Leeds CITY COUNCIL

Report of the Chief Planning Officer

Subject: APPLICATION 14/06550/FU – Application for single storey rear extension at Flat Number 6, The Acres, The Avenue, LS17 7FD.

Proposed Ground Floor Plan
Scale 1:50

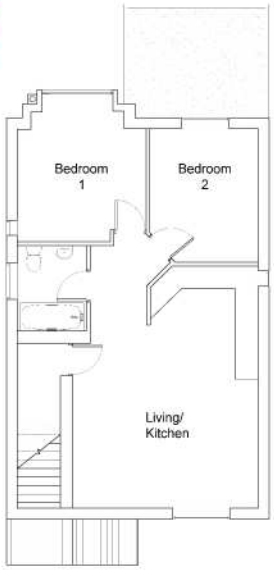
C	Flat Roof balcony omitted	18.12.2014
B	Fire line missing and proposed plans added. Windows amended to include sliding corner and other.	12.11.2014
A	Roofs: proposed conversion exercise / contextually added	27.10.2014
	REVISIONS	DATE
